**Canterbury Earthquakes  
Royal Commission of Inquiry  
into the CTV Building Collapse**

Critique of

**CTV Site Examination and Materials Tests Report**  
by Hyland Fatigue + Earthquake Engineering  
*16 January 2012*

**CTV Building Collapse Investigation Report**  
by Hyland Fatigue + Earthquake Engineering/StructureSmith  
*25 January 2012*

**Figure 2: Column test strength distribution. Special Grade Concrete versus High Grade Concrete aged 25%**

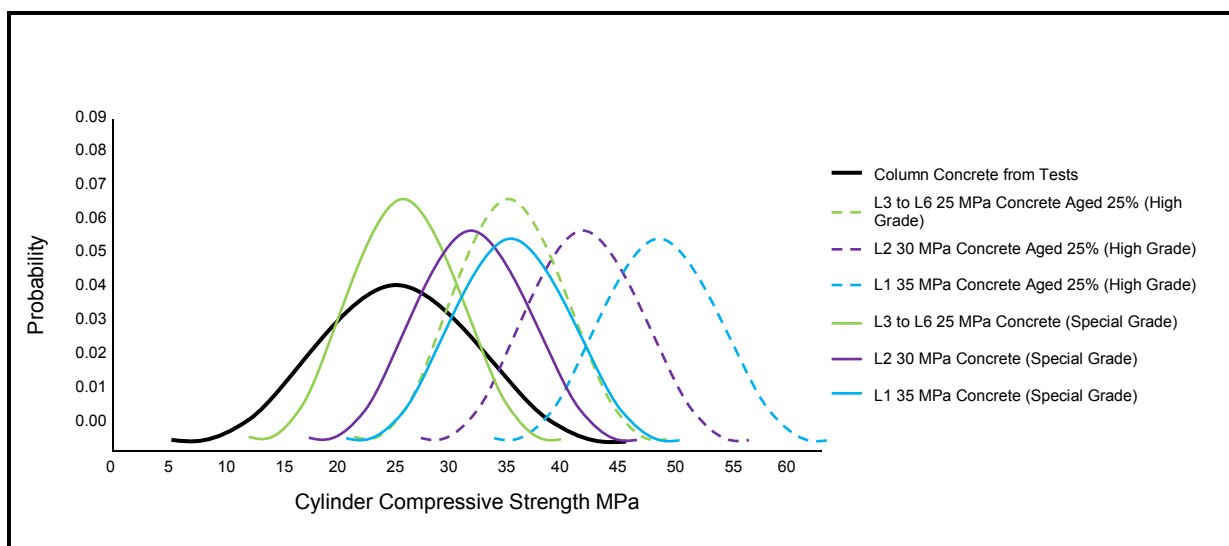
Table 3 on page 63 in the Hyland Materials Report also assumes the concrete supplied to construct the CTV Building was from a *High Grade* ready mixed concrete plant. In fact, on the advice of the New Zealand Ready Mixed Concrete Association (NZRMCA), all the urban concrete plants supplying Christchurch at the time were *Special Grade* plants (D.P. Barnard, personal communication, April 3, 2012). A *Special Grade* plant has a lower target mean strength of 3 MPa to reflect the higher level of quality control. Thus the data in Table 3 are 3 MPa too high and the associated statistical data is in error. This also introduces an error into the distribution curves in Figures 51 and 52 (pp. 71 & 72) of the report.

Based on Table 3, the Hyland Materials Report concludes that the mean strength of the columns tested was equivalent to that for a concrete with a 28 day specified strength of 20 MPa. As the floor level from which 10 of the 19 columns tested is unknown, CCANZ considers that one cannot come to any conclusions on the compliance of individual results. However, because the mean strength was incorrectly established as being equivalent to a 20 MPa concrete, the Hyland Materials Report concludes that the columns on levels one, two and three to six may not have achieved the 28 day specified strength of 25 MPa for levels three – six, 30 MPa for level two or 35 MPa for level one. CCANZ believes that no such conclusion can logically be made, and for the ten columns where the floor level is unknown, no conclusion can be drawn on the adequacy of the concrete in meeting the specified strength.

Table 1 and Figure 2 below show the revised target mean strengths for 25 MPa, 30 and 35 MPa specified strength by removing the ageing and target strength errors, and demonstrates the significance of the reduction.

Specified Strength	20 MPa	25 MPa	30 MPa	35 MPa
<b>Target Mean Strength (TMS) based on:</b>				
NZS 3104 High Grade and Ageing applied in Hyland Materials Report	34.4 MPa	41.9 MPa	50.0 MPa	56.9 MPa
NZS 3104 Special Grade TMS as should have been applied	24.5 MPa	30.5 MPa	36.5 MPa	42.5 MPa
